**Report to General Manager**

SUBJECT: Modifications 6 and 7 to approved commercial building at 77-81 Berry Street, North Sydney, now known as 1 Denison Street, North Sydney.

AUTHOR: Geoff Mossemeneer, Executive Planner

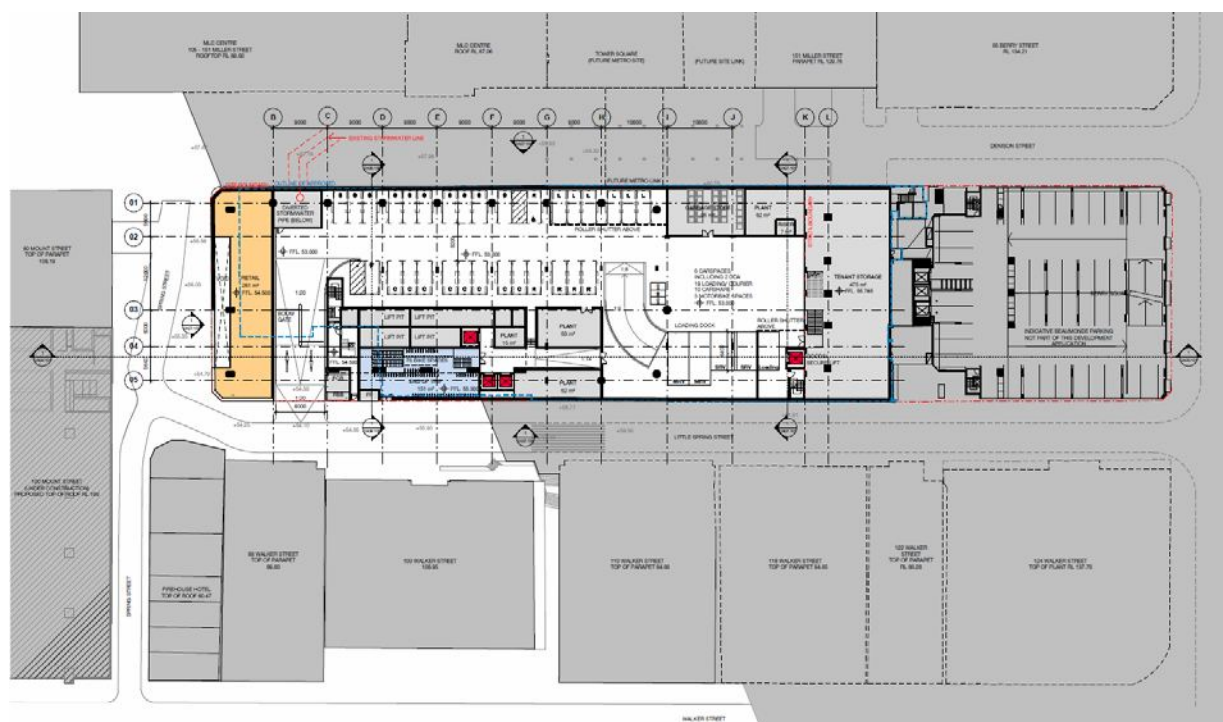
The modelling confirms there will be no additional overshadowing on the Neutral Bay or Kirribilli residential areas to the south of the subject site prior to 2pm. There will be some additional shadow that occurs on the residential dwellings at Whaling Road, Neutral Bay from 2:45pm onwards.
